# CITY OF ALBUQUERQUE

**RE: 99999 86<sup>th</sup> St SW**  
**Grading and Drainage Plan**  
**Engineer's Stamp Date: Missing**  
**Hydrology File: L10D032**  
**Case # HYDR-2026-00006**

Based upon the information provided in your submittal 1/9/2025, the Grading and Drainage Plan **is not approved** for Grading Permit and Building Permit. The following comments need to be addressed for approval of the above referenced project.

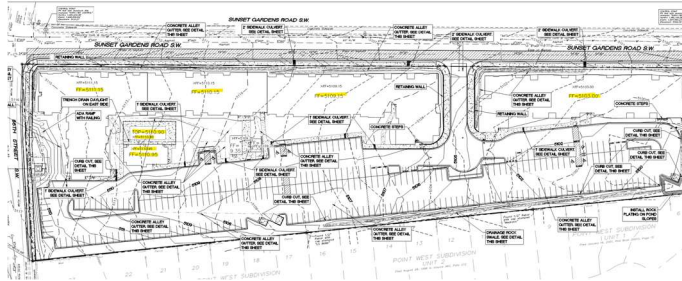
4. Please provide the FIRM Map and floodplain note **with effective date**.

Include effective date here

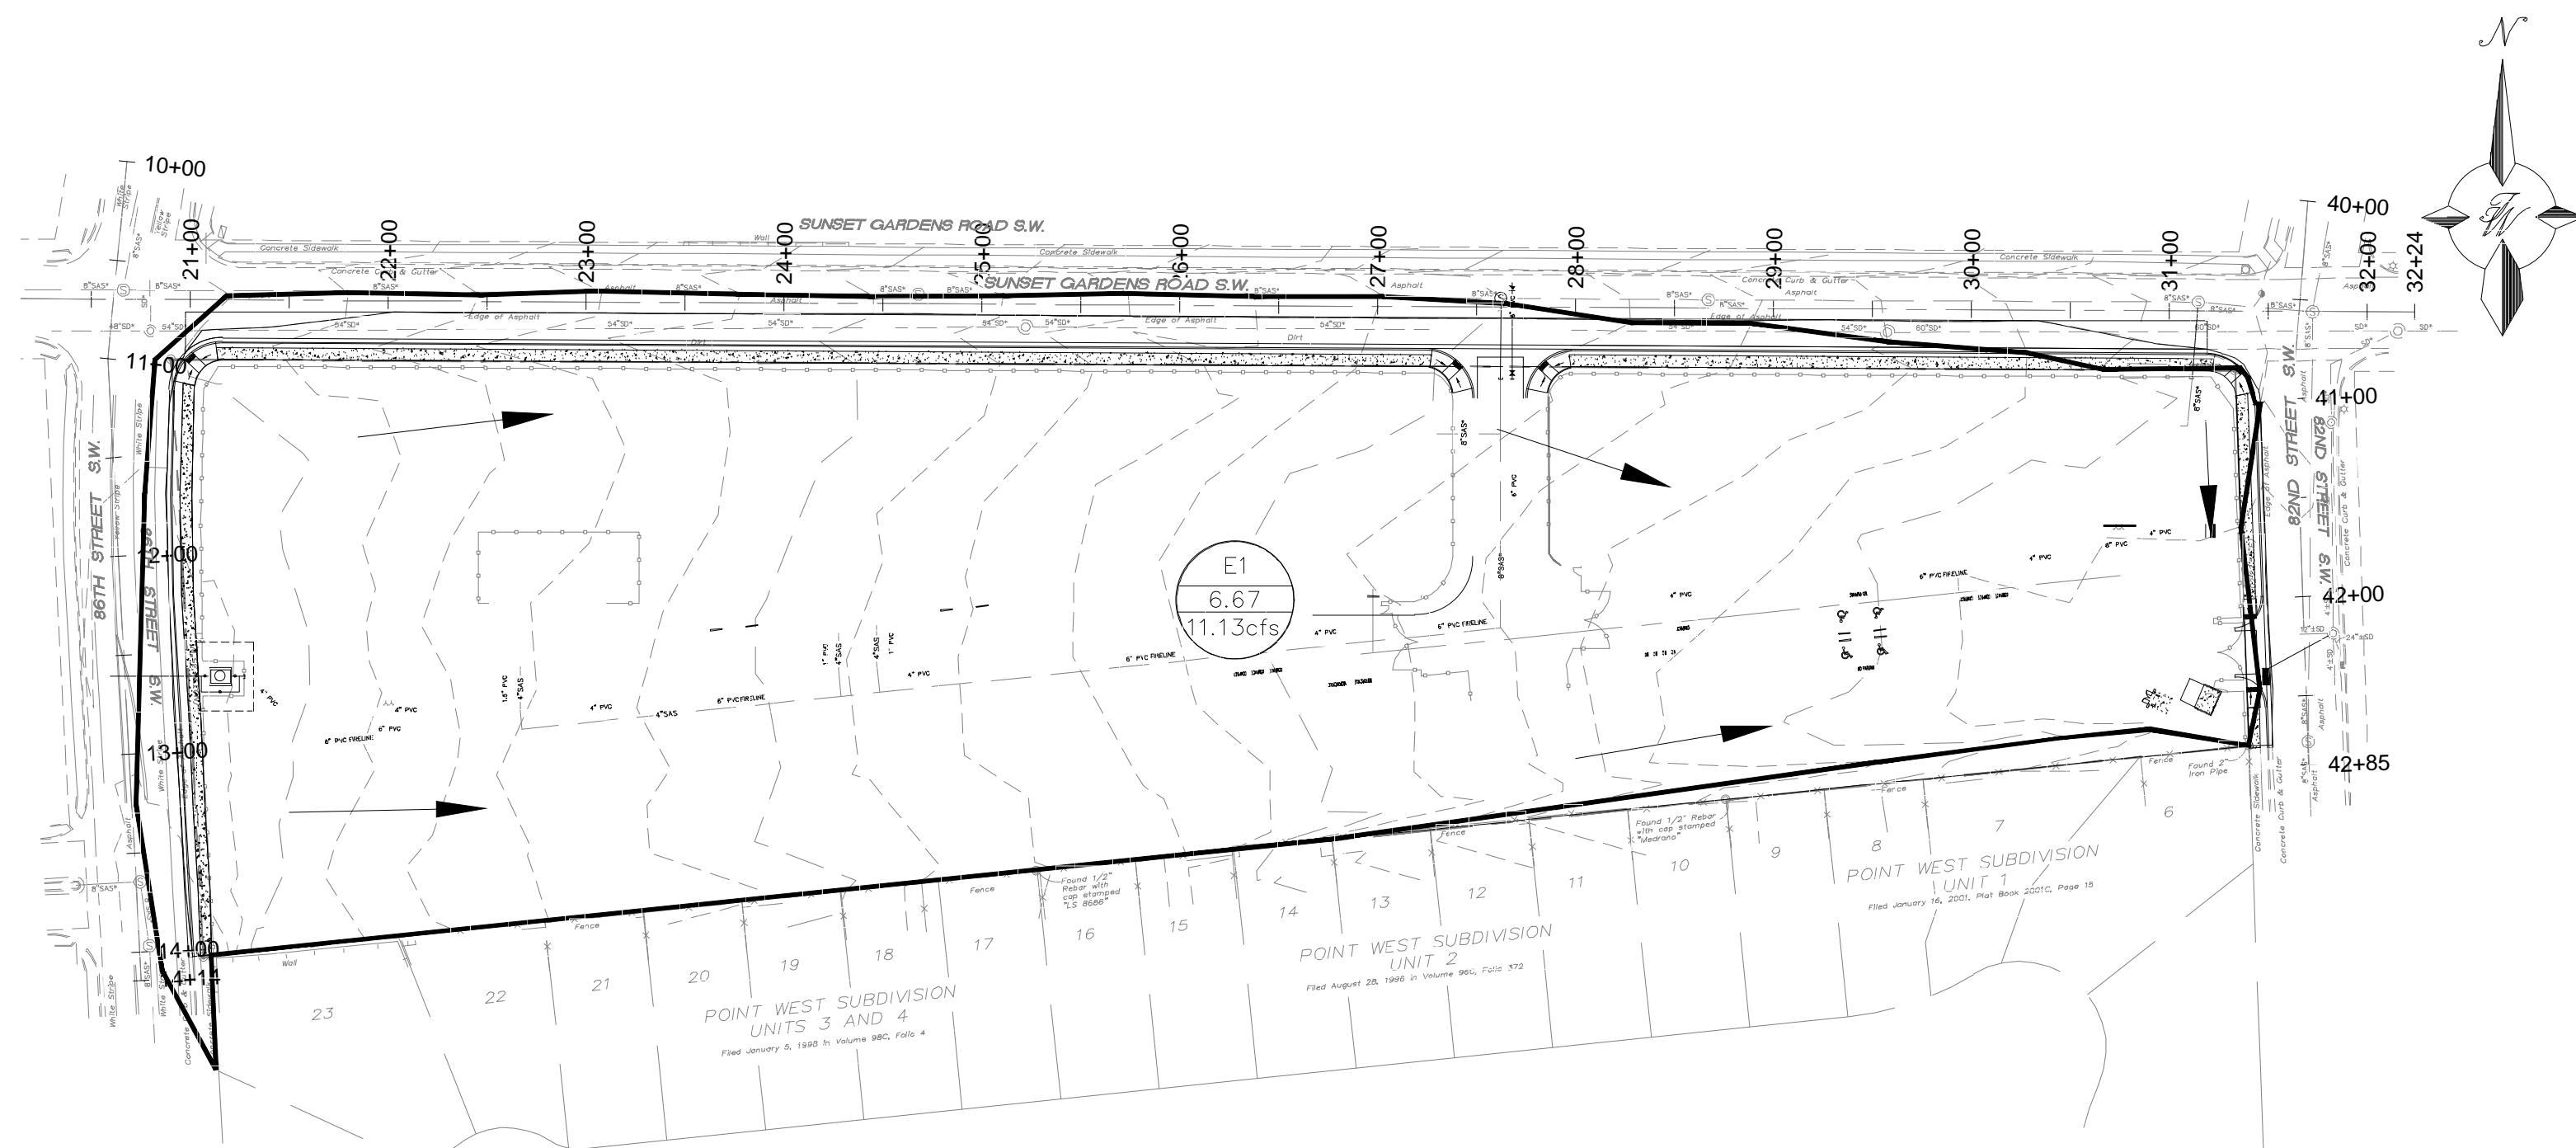
5. Please number the ponds and include a label on each with the SWQV and elevation, the 100-year volume and elevation, the peak 100-year inflow and outflow, the spillway crest elevation, the spillway flow depth, and the dam top elevation.
6. Please show finished pad (FP) elevation and Finished Floor (FF) elevation. Should not be the same value.

7. What is going to happen to the water on the southwest side of the property? Please demonstrate on the plans how water will enter the rock swale and not cross over the property line to the south.
8. Indicate on the plans where the roof drains will drain to.
9. Update note to say: "No work shall be performed in the public ROW without an approved Work Order or Excavation Permit."
